CUYAMA BASIN GROUNDWATER SUSTAINABILITY AGENCY STANDING ADVISORY COMMITTEE

AGENDA

November 29, 2018

Groundwater Sustainability Plan Update

Figure 2.2-1 - Cuyama Basin Landmarks

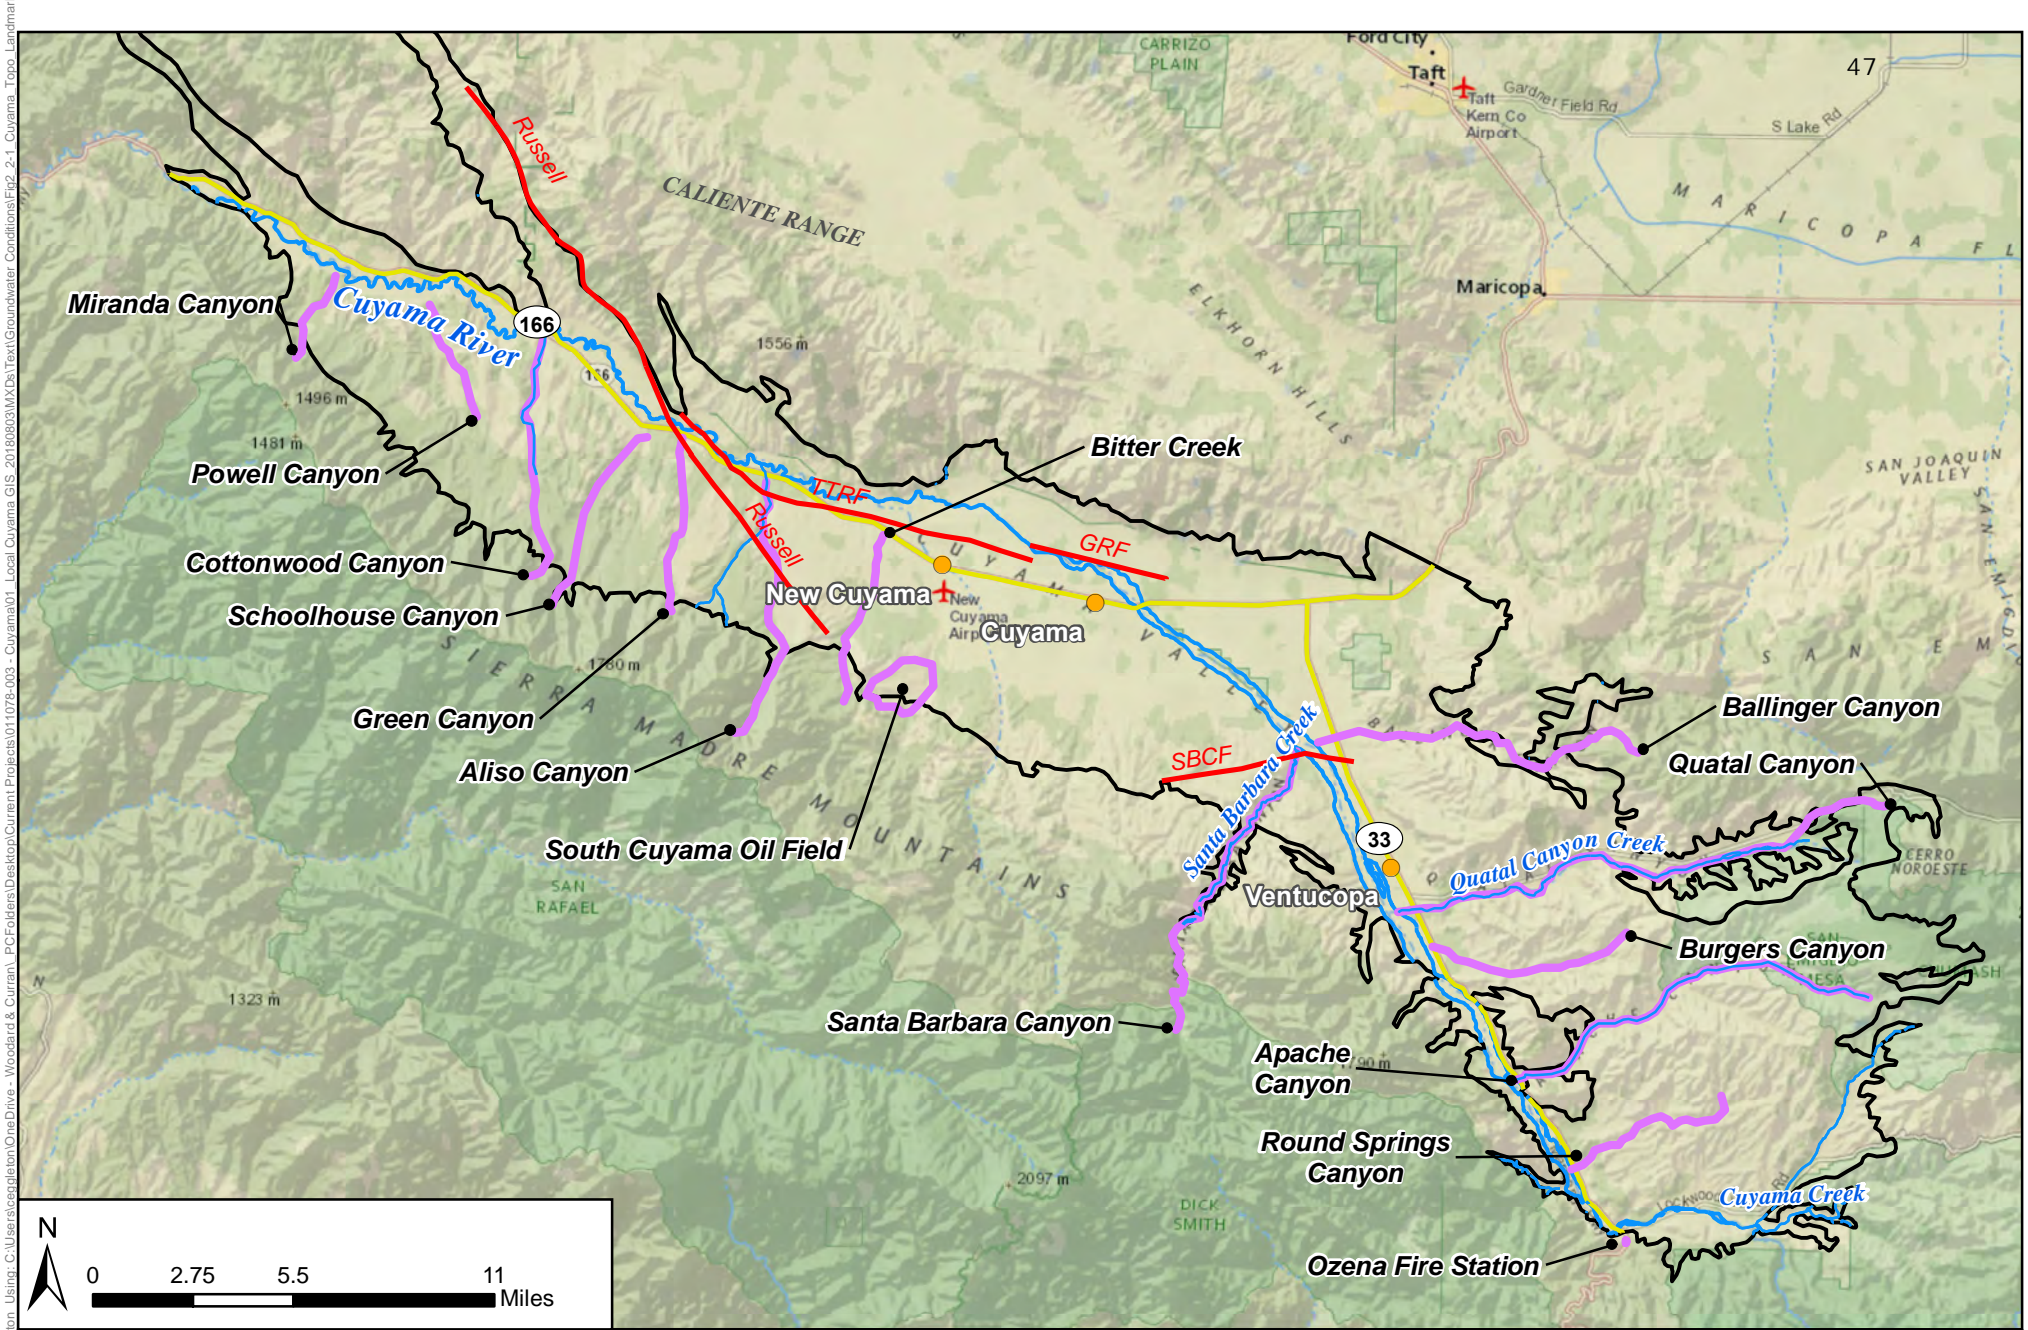
52	Jane Wooster	CBGSA Board member	Figure 2.2-1				On Figure 2.2-1 the location of the Russell Ranch Oil Field is not too accurate...it is also wrong on OPTI ID (Jane to send Brian a map).	Russell Ranch Oil Field has been removed from the figure.
53	Jane Wooster	CBGSA Board member	Appendix X				In the hydrographs (appendix X), many of the wells on our place are no longer there. It is misleading because some wells were drilled, tested once and that was it. I guess they give info about water depth.	The maps and data in Appendix X are intended to show the groundwater level information that is available historically in the Basin. Because of this, many wells that no longer exist will be included.
54	Jane Wooster	CBGSA Board member	Figures Y-4 & Y-6				Just based on what I know the stats were on our wells, it looks like Figures Y-4 and Y-6 are over-generalized. Some places we saw differences and some places the Wells didn't fluctuate all.	Comment noted. The contour maps represent estimates based on the available information in each period.

Figure 2.2-5: Cuyama GW Basin Wells with Monitoring Data Provided by Private Landowners

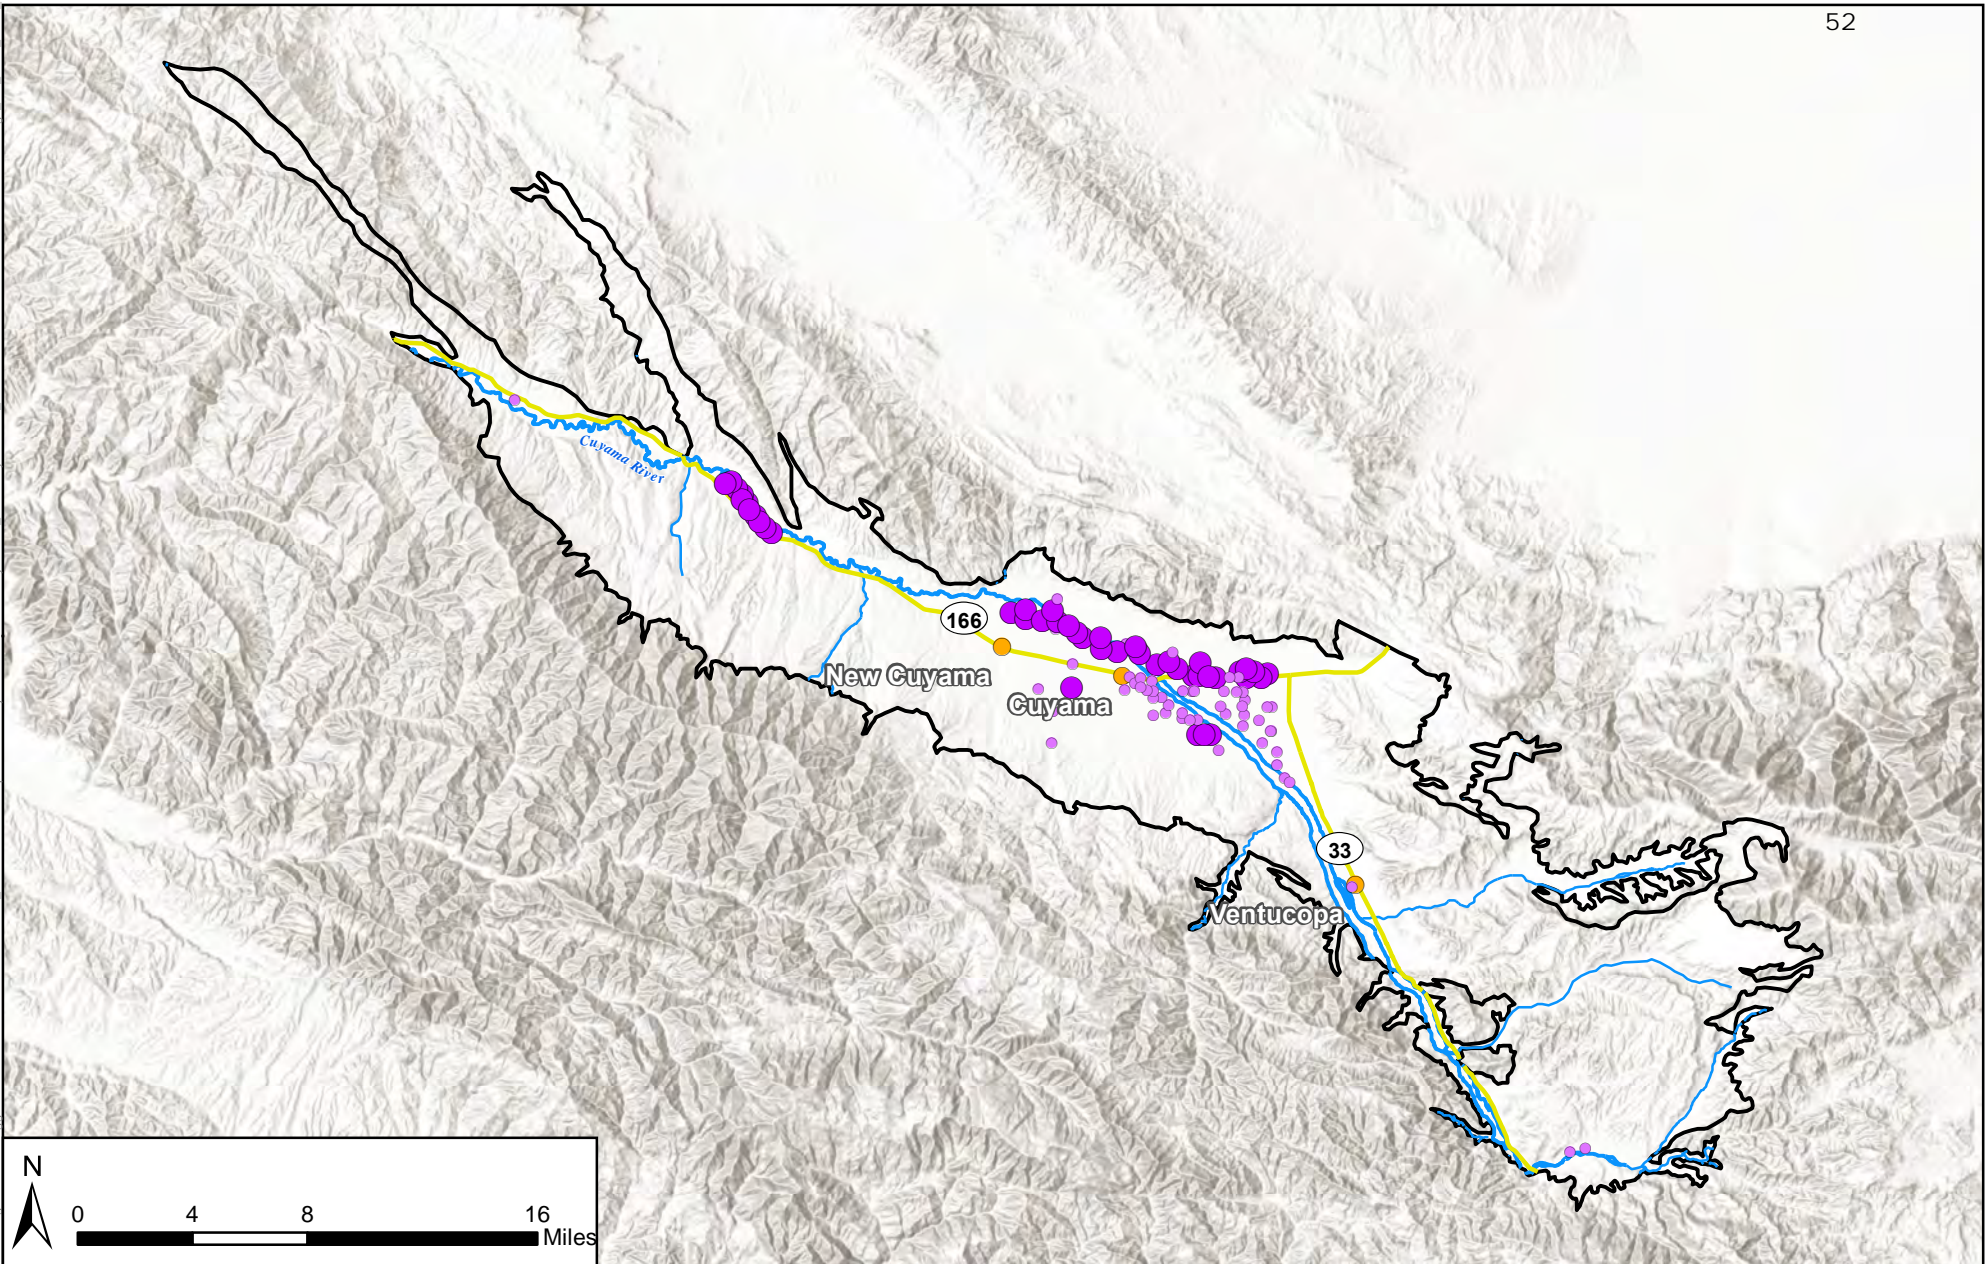
Comment #	Commenter	Commenter Organization	Section	Section Paragraph #	Paragraph's Sentence #	Sentence Starts with, "...	Comment	Response to Comment
136	Matt Young, Matt Scudato, & Fray Crease	Santa Barbara County Water Agency	Figure 2.2-5				Again, misleading title here vs. actual figure which states "Owners and Operating Entities" SBCWA does not own or operate the wells assigned to us in this graph. We only own and maintain CVFR, CVKR, and CVBR. Further this map does not include most of the wells measured by the SBCWA	The figure title has been revised for clarity
137	Matt Young, Matt Scudato, & Fray Crease	Santa Barbara County Water Agency	2.2.3 GW Trends				This section needs major reorganization. There is a time based section, then a number of other sections without a designated timeframe. Also, the wording in this section needs a thorough review by a technical editor.	The text has been revised for clarity.

Figure 2.2-7: Central Cuyama GW Basin Wells and Hydrographs by Data Source

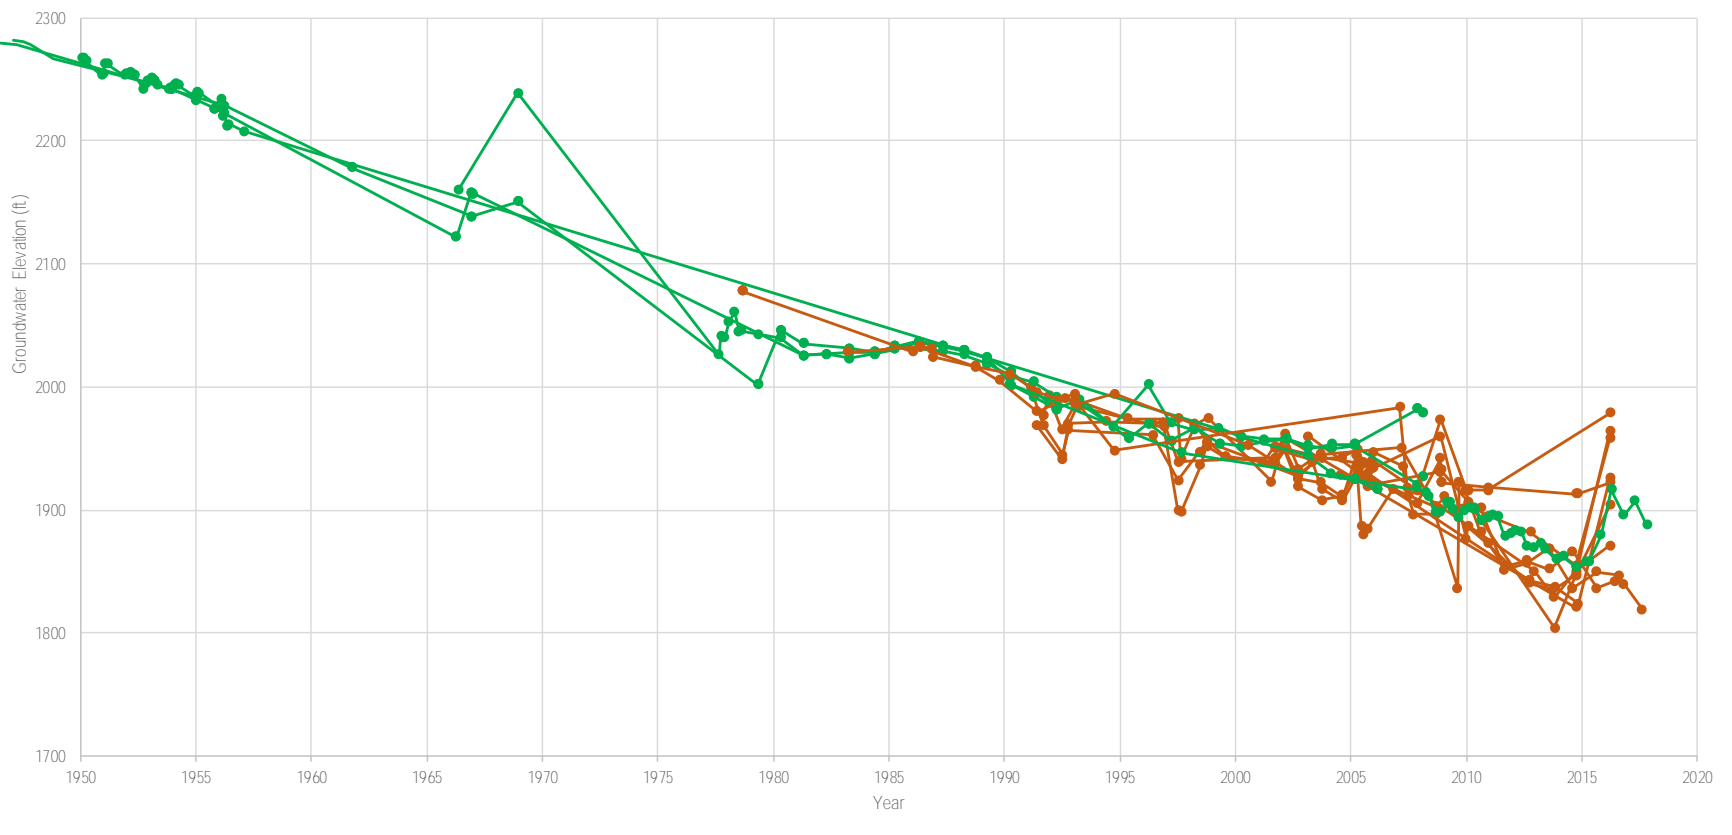
132	Matt Young, Matt Scrudato, & Fray Crease	Santa Barbara County Water Agency	2.2.2 GW Elevation Data Processing			Figure 2.2-7 shows a comparison of data	Need context to explain why this comparison is being done.	Text has been revised for clarity.
133	Matt Young, Matt Scrudato, & Fray Crease	Santa Barbara County Water Agency	2.2.2 GW Elevation Data Processing			Figure 2.2-8 shows a comparison of data	Need context to explain why this comparison is being done.	Text has been revised for clarity.
134	Matt Young, Matt Scrudato, & Fray Crease	Santa Barbara County Water Agency	Figure 2.2-8				The need for this statement and graph appears to be validation for the quality of water level data provided by Grapevine Capital Partners. Please remove both the discussion (page 2.2-11) and the graph as these data illustrates nothing at all. 1. Two of the Santa Barbara County wells are not even part of the network. I don't even think these wells exist in the Valley. It is unclear where these data came from. 2. You appear to be comparing very shallow wells to a 6 of the 12 deep production wells. 3. Are these discrete static water level measurements used for the Grapevine data or select points from the continuous 5-minute data sets? SBCWA has been making periodic discrete water level measurements at the 12 productions wells on the Harvard property. A comparison of 26 measurements shows differences between discrete water level and computed water levels ranging from -47.9 feet to 150.36 feet. These are large outliers when compared to all the measurements, but would be a better indication of the data quality (see chart below). SBCWA has measurements from 9/2018 to compare as well. There would be some variation of only a few feet in this comparison based on equipment PSI (most likely higher PSI being used due to large level changes and therefore reduced accuracy), MP elevation choice, computation procedures, etc. Please contact Matt Scrudato to discuss specifics.	The figure is included because of interest expressed during public meetings regarding how data provided by private landowners compares with data provided by public agencies. The text describing the figure has been revised for clarity.
